M9803A-03

Information Only Service Note

M9803A PXIe Vector Network Analyzer

False alarm on self-test failure on firmware revision of A.13.40.02 - DDR3 memory removal

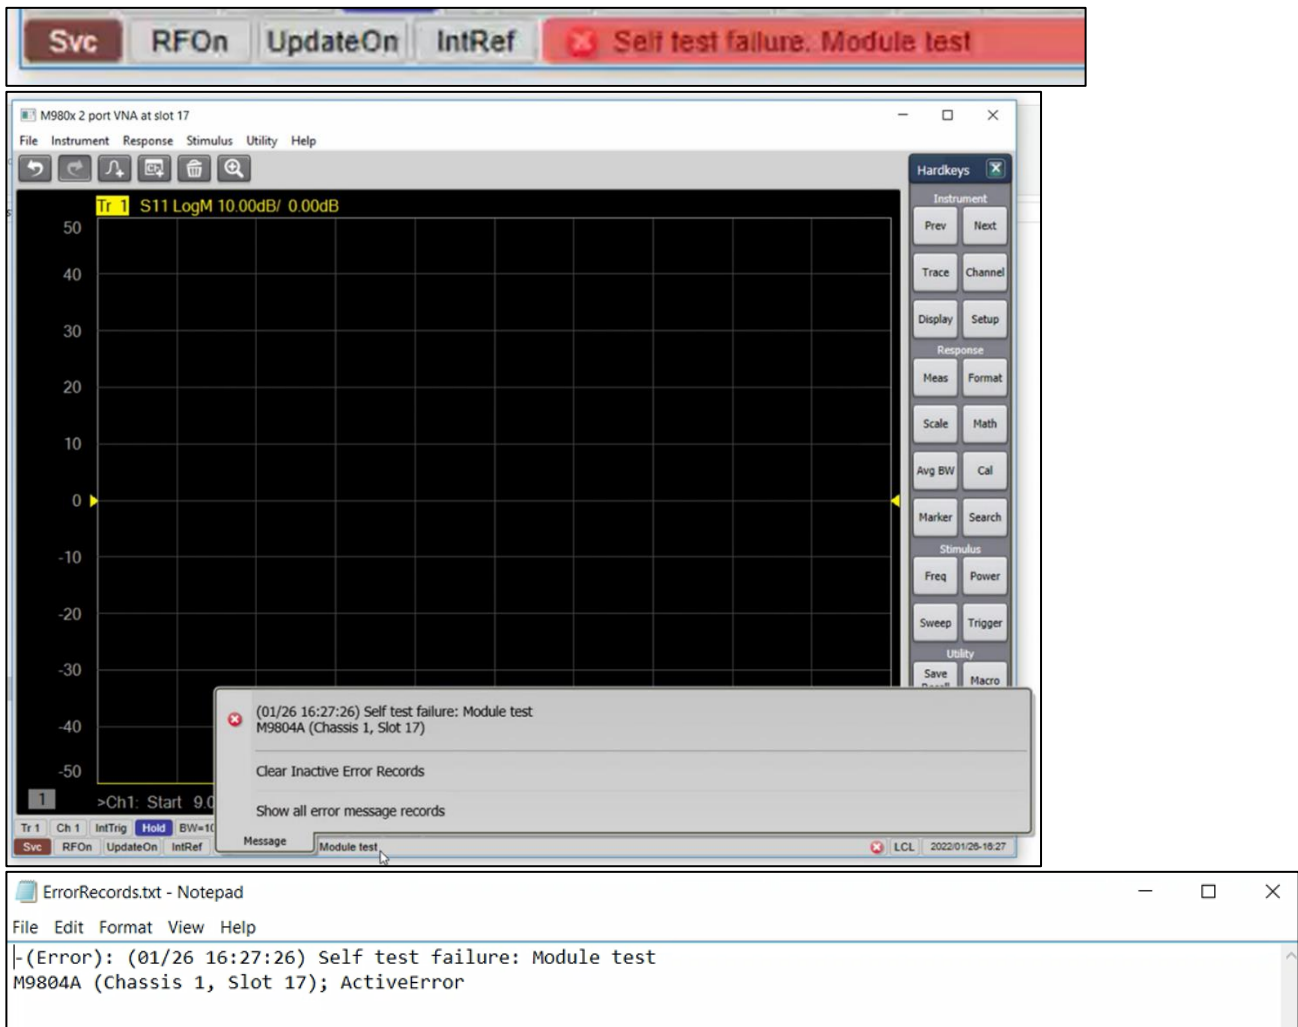
The on board DDR 3 memory in VNA is not in use since its release. With the removal of DDR 3 memory IC on newer M980xA VNA, right after firmware is launched, false alarm (self-test failure) will be reported as shown. This has no impact to VNA performance and specifications.

Similarly, firmware will report a false failure in Operator check. Shown are the error messages example on VNA firmware UI.

For users with firmware revision of A.13.40.02,
Update firmware to revision A.13.70.02 or newer to resolve this false alarm on self-test.
